**TO:** Chairwoman Carlotta Harrell, Henry County Commission  
**ATTN TO:** Kenta Lanham, Planner III, Henry County  
**FROM:** Mike Alexander, COO, Atlanta Regional Commission  
**RE:** Development of Regional Impact (DRI) Review

**Name of Proposal:** Strickland Tract DRI 4251

**Description:** A DRI review of a proposal to construct a data center project with 1,253,754 SF of space in 4 buildings and associated support elements on a 250-acre partially wooded site on Strickland Road east of Simpson Mill Road in Henry County.

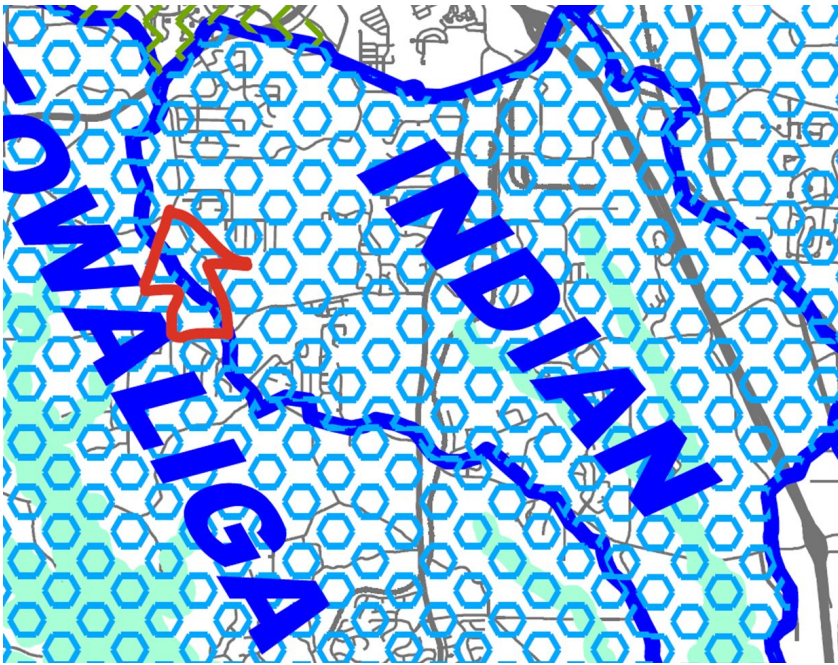
The project is in both the Limited Development Area of Towaliga (TRWPA) and Indian Creek HCWA Watershed Protection Area (ICWPA).

Site plan only indicates TRWPA. (See general outline in red for property boundary image below. Hexagon indicates limited development area.) Note that the site plan is oriented with north to the left. Vicinity map shows site as image below, north straight up.

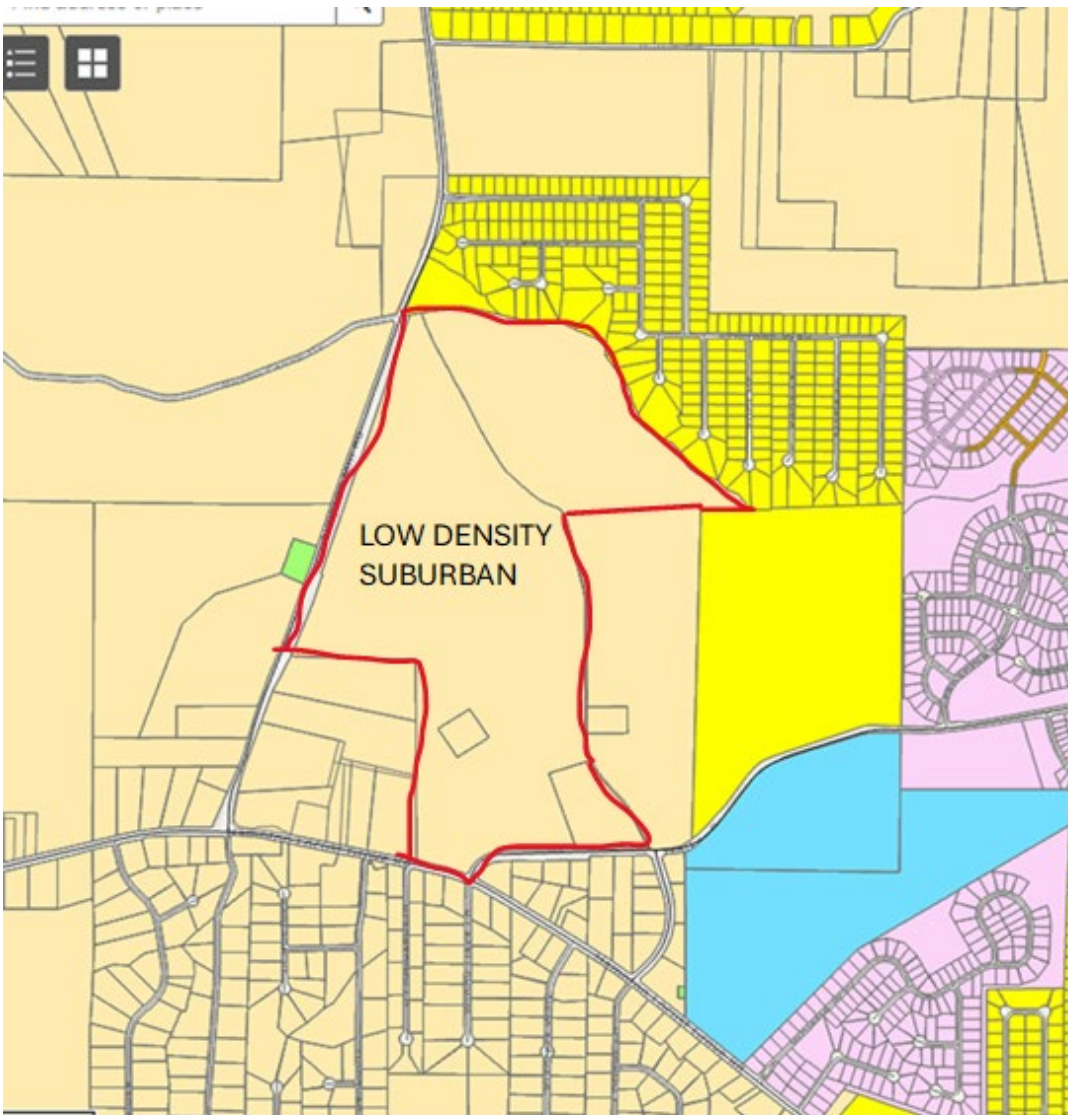
Development regs. OI = Max. ht. for new development is unlimited. This detail should be shown on the plan and discussed as to the visual impact of the rural area.

Additionally, the long building façade along Simpson Mill Road will be quite altering for

the rural character of the area. The building length is 1,661' which is 0.31 miles.

What is the elevation of Simpson Mill Road? Maybe 910 at midpoint of building, ask applicant approx. FFE of Building and Ht. of building proposed. A 50' buffer planted of evergreen material will never screen this building if it sits at the same elevation as the road and is allowed an unlimited height per the zoning regulations.
